**MONTGOMERY COUNTY  
PLANNING COMMISSION**

Re: MCPC #17-0266-001  
Plan Name: 9 Presidential Boulevard  
(1 lot/173 du and 5,000 sq. ft. commercial on approximately 2.74 acres)  
Situate: Presidential Boulevard (east)/City Avenue (north)  
Township of Lower Merion

We have reviewed the above-referenced tentative sketch plan as you requested on November 16, 2017. We forward this letter as a report of our review.

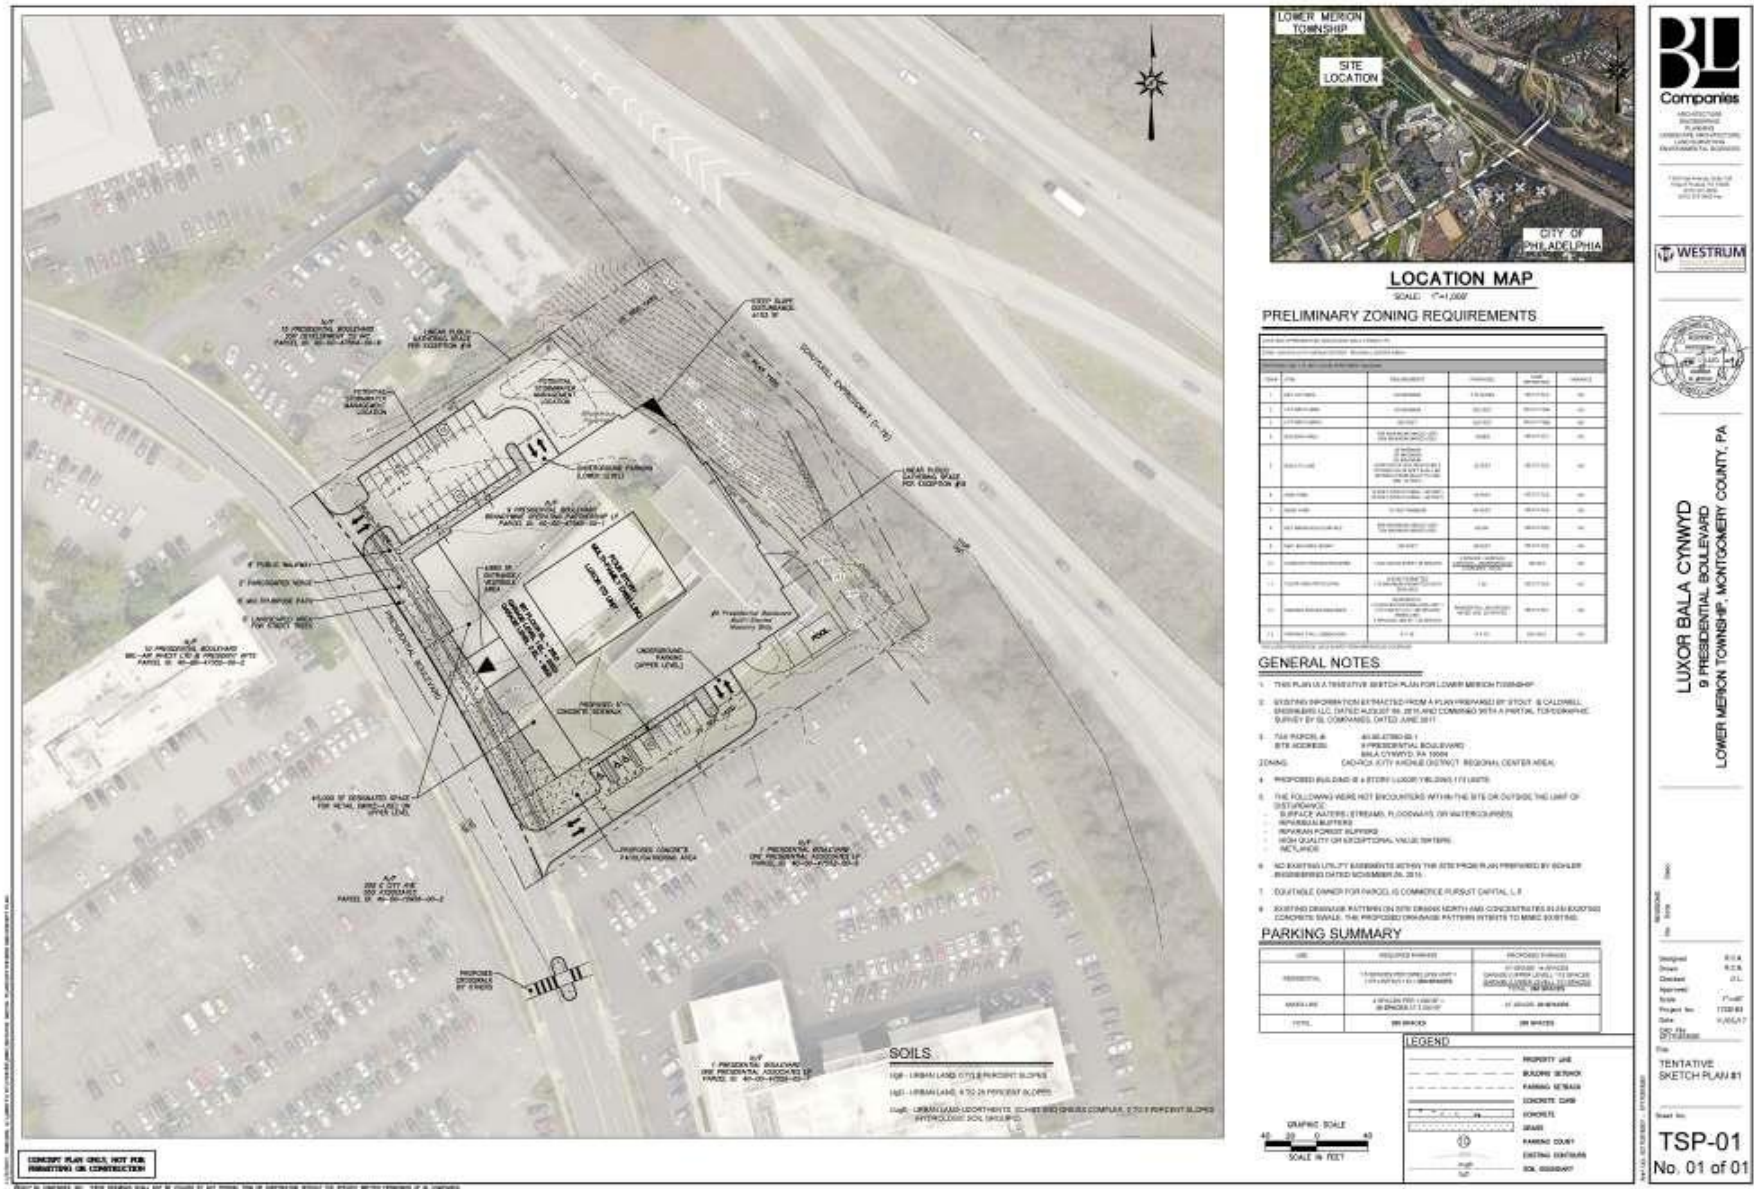
- B. Number of Driveways. Section 155-217.D.(1)(d) of the Township's zoning ordinance states that "Only one curb cut/driveway is permitted on each street frontage of each lot." Scenario 1 as shown on Sheet TSP-01 shows two driveways on the Presidential Boulevard street frontage of the site.

- B. Scenario 1. Sheet TSP-01 shows two driveways with access to Presidential Boulevard. The proposed driveway on the eastern side of the proposed building appears to be very close to the westernmost existing driveway on the adjacent property. We encourage the applicant to coordinate with the adjacent property owner regarding potential benefits that could result from sharing parking lot access between the two sites and removing one of the closely-spaced driveways.

Several parking spaces are shown just inside of the proposed driveway entrance off of Presidential Boulevard on the eastern side of the proposed building. The applicant should work with the Township to ensure that there is sufficient space for vehicles entering and exiting the site to maneuver safely in this area. One option would be to remove the parking spaces on either side of the driveway, for a reasonable depth to provide for sufficient queuing space between the parking spaces and the busy driveway entrance. The additional space created could be used for increased vegetation.

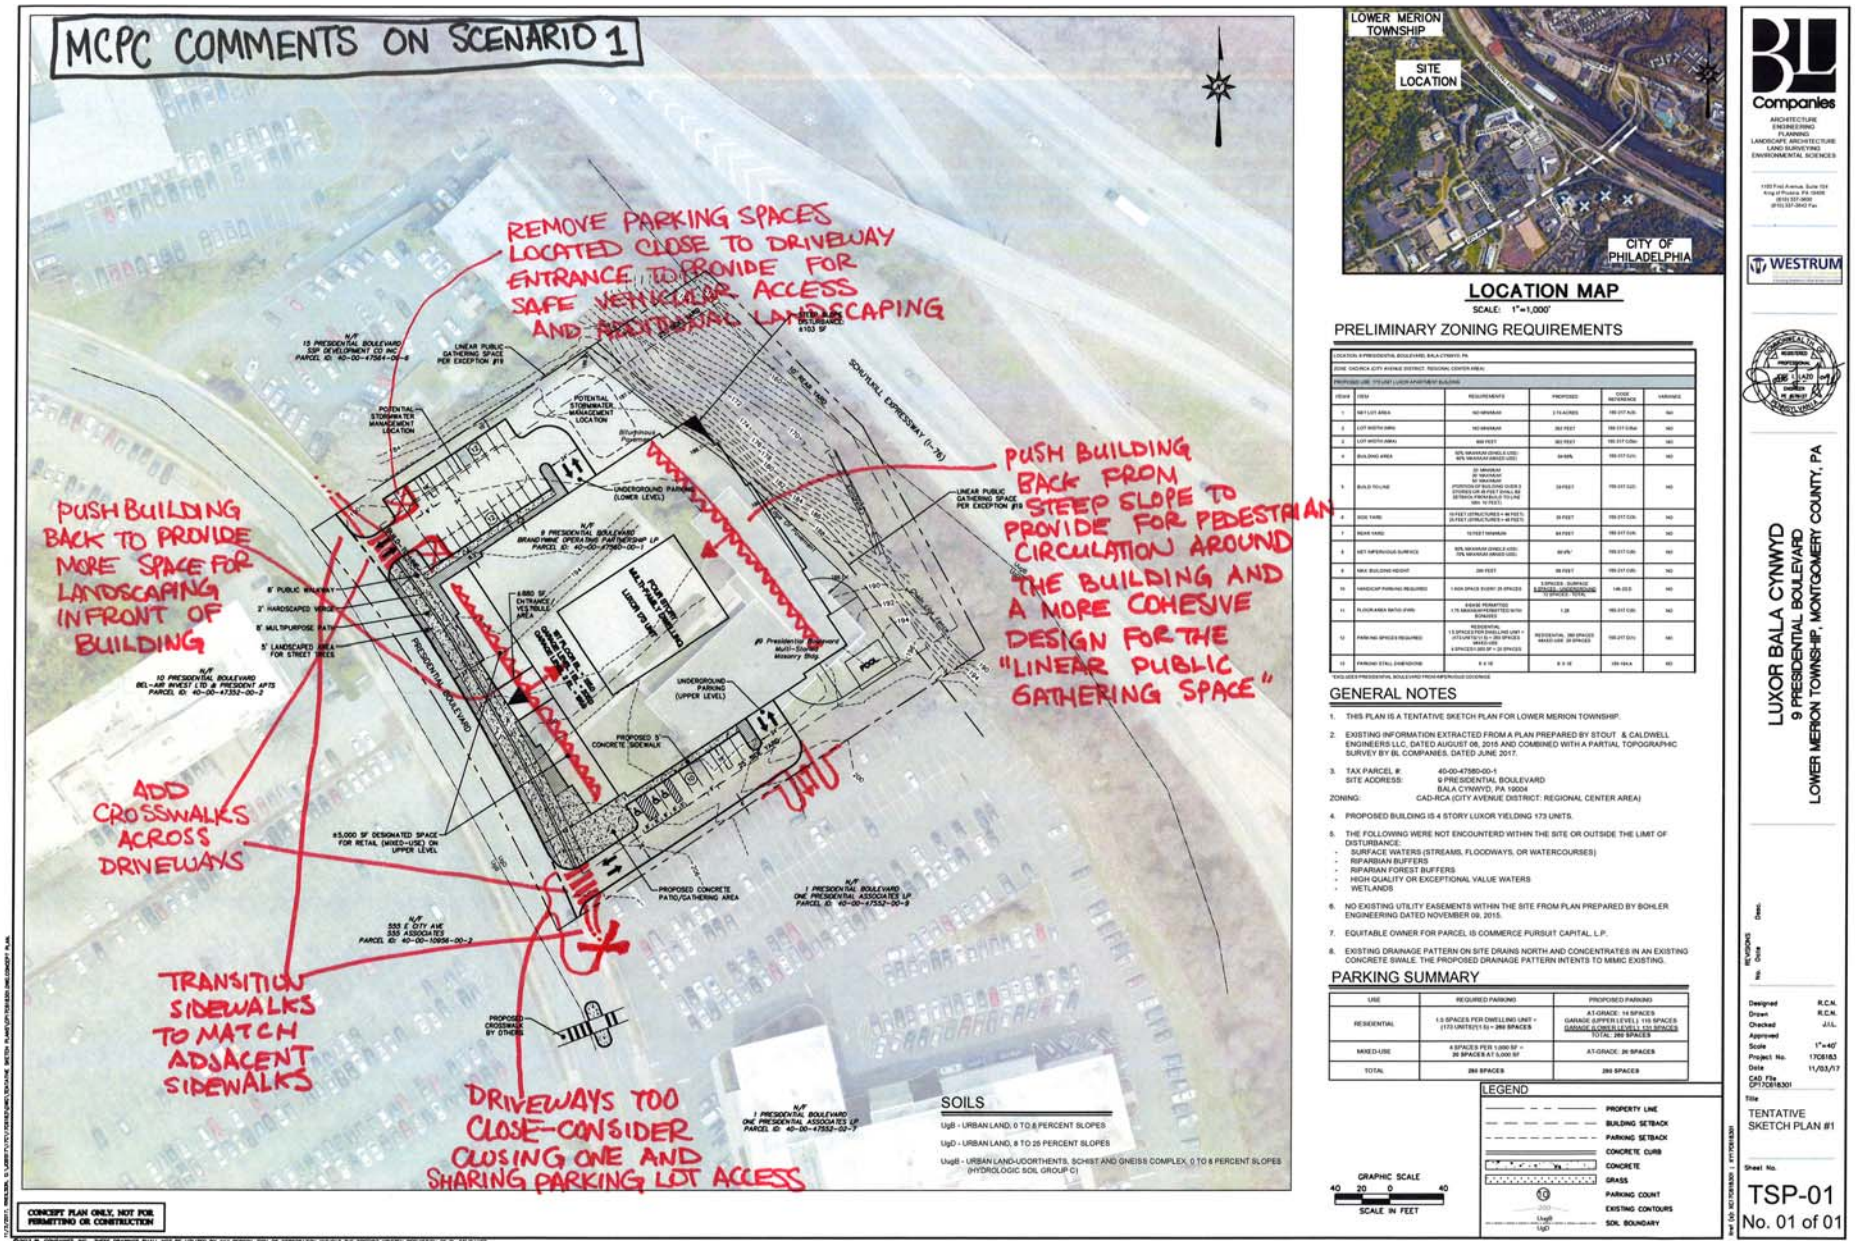
- C. Scenario 2. Sheet TSP-02 shows one driveway with access to Presidential Boulevard on the eastern side of the proposed building. Several parking spaces are shown just inside of this driveway entrance with one parking space shown to be approximately 15 feet from the Presidential Boulevard curbline. The applicant should work with the Township to ensure that there is sufficient space for vehicles entering and exiting the site to maneuver safely in this area. The Parking Summary of Sheet TSP-02 shows that 293 parking space are proposed where 260 are required. Therefore, we strongly encourage the applicant to remove several parking spaces on the northern side of the driveway to provide for sufficient queuing space between the parking spaces and the busy driveway entrance. The additional space created could be used for increased vegetation.
